HISTORIC AND DESIGN REVIEW COMMISSION

June 02, 2021

HDRC CASE NO: 2021-239
ADDRESS: 106 PARKVIEW DR
LEGAL DESCRIPTION: NCB 6919 BLK LOT 5 & 6
ZONING: R-5, H
CITY COUNCIL DIST.: 3
DISTRICT: Mission Historic District
APPLICANT: Matthew Longoria/LONGORIA MATTHEW JACOB
OWNER: Matthew Longoria/LONGORIA MATTHEW JACOB
TYPE OF WORK: New construction
APPLICATION RECEIVED: May 10, 2021
60-DAY REVIEW: Not applicable due to City Council Emergency Orders
CASE MANAGER: Edward Hall

The applicant is requesting a Certificate of Appropriateness for approval to construct a 1-story, single-family residential structure on the vacant lot at 106 Parkview Drive, located within the Mission Historic District.

501 RIGHT VIEW
SCALE----- 1/4" = 1'-0"

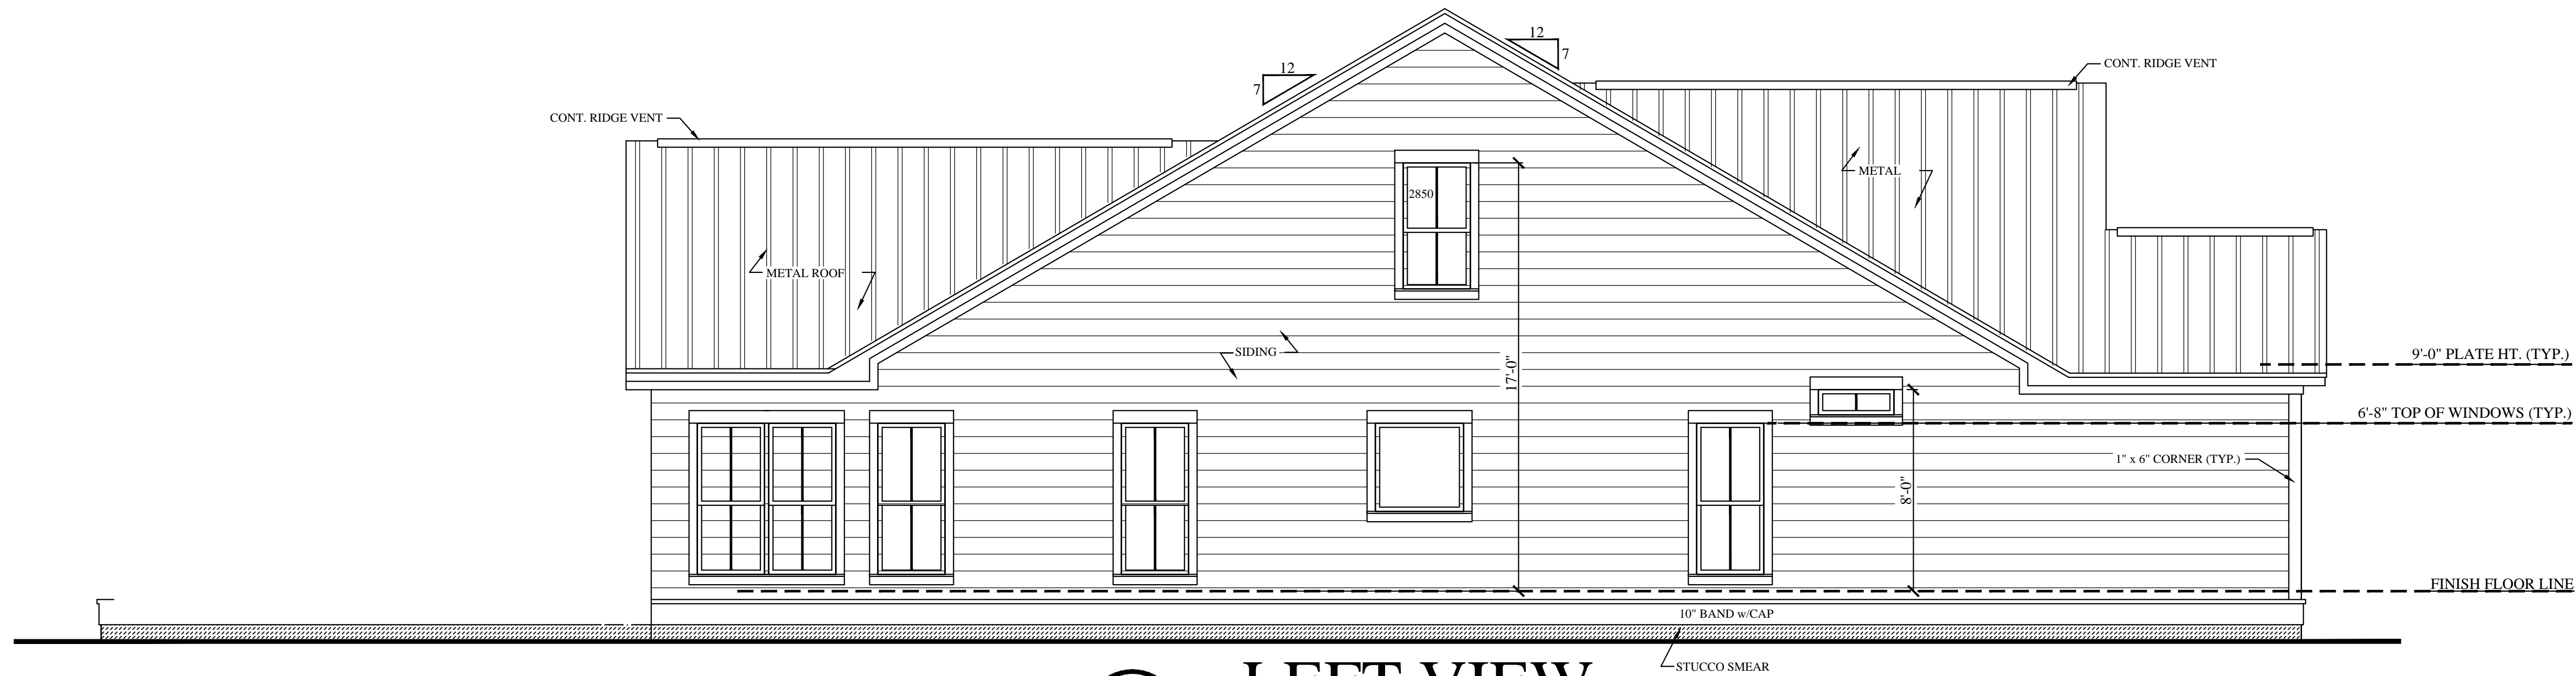
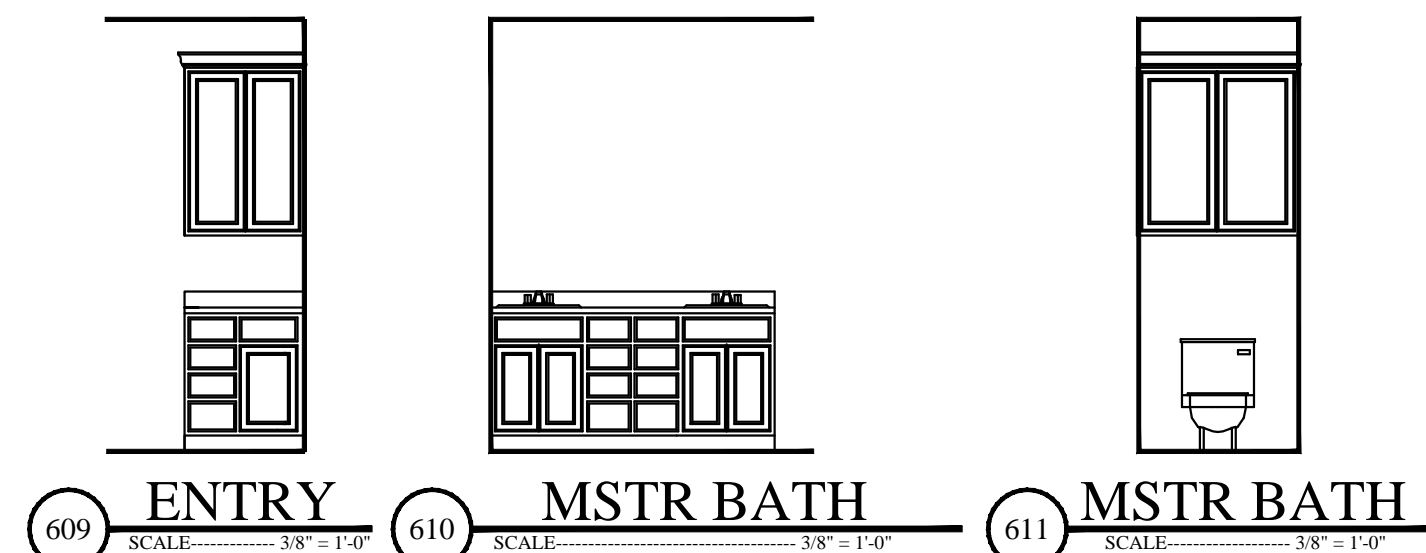
- g. ROOF FORM – The applicant has proposed roof forms that include both front and side gabled roofs. Generally, staff finds the proposed roof forms to be consistent with the Guidelines for New Construction; however, staff finds that all gable returns should be eliminated from the proposed roof forms.

- k. WINDOW & DOOR OPENINGS – Per the submitted documents, the applicant has proposed window profiles and fenestration patterns that are generally consistent with those found historically within the district and the Guidelines for New Construction.

- l. ARCHITECTURAL DETAILS – The applicant's proposed design generally feature architectural details that are found historically within the Mission Historic District and are consistent with the Guidelines for New Construction. Staff finds that columns should be six (6) inches square and feature capital and base trim as well as chamfered corners.

- i. That the applicant eliminate all gable returns from the proposed roof structure in favor of a sloped soffit.
- ii. That the proposed standing seam metal roof feature panels that are smooth and 18 to 21 inches wide, seams that are 1 to 2 inches in height, a crimped ridge seam or a low profile ridge cap and a standard galvalume finish. A darker gray color may also be approved by the Commission. Additionally, staff recommends that columns be six (6) inches square and feature capital and base trim as well as chamfered corners. A column detail is to be submitted to staff for review and approval.

100 SERIES SINGLE-HUNG WINDOW

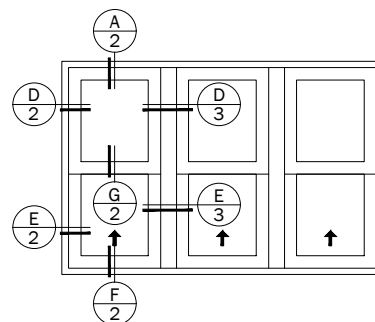
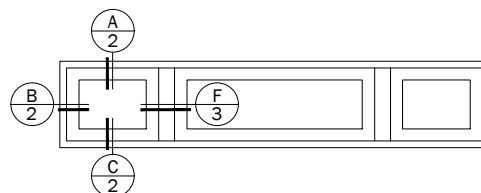
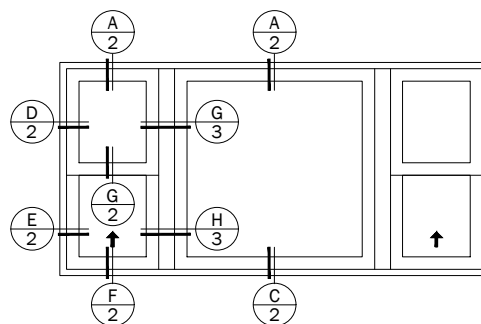
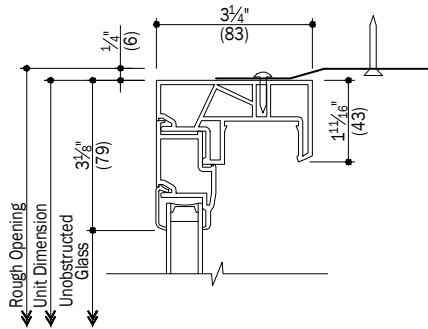
- j. WINDOW MATERIALS – The applicant has proposed Anderson 100 Series windows, which feature composite materials. The proposed windows will feature a nailing fin and dimensions that are not consistent with staff's standards for windows in new construction. Staff finds that windows that are consistent with staff's standards for windows in new construction be installed. The Commission may motion to approve a specific window product.

- iii. That the applicant install a wood or aluminum clad wood windows that is consistent with staff's standard specifications for windows in new construction, as noted in finding j.

**ML-150****1.5" MECHANICAL LOCK**

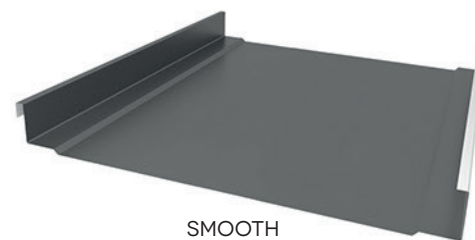
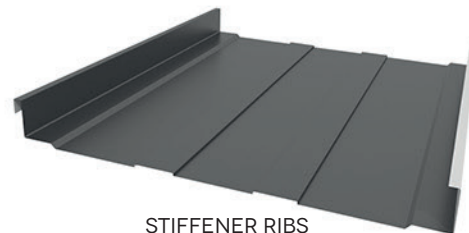
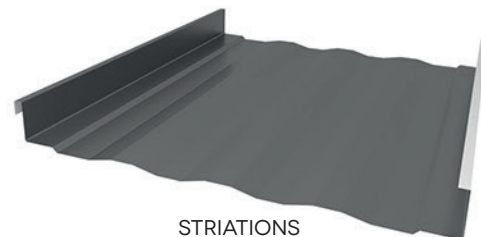
- i. MATERIALS – The applicant has proposed materials that include wood siding and trim and a standing seam metal roof. Staff finds the use of wood siding and trim to be appropriate. The proposed standing seam metal roof should feature panels that are smooth and 18 to 21 inches wide, seams that are 1 to 2 inches in height, a crimped ridge seam or a low profile ridge cap and a standard galvalume finish. A darker gray color may also be approved by the Commission.
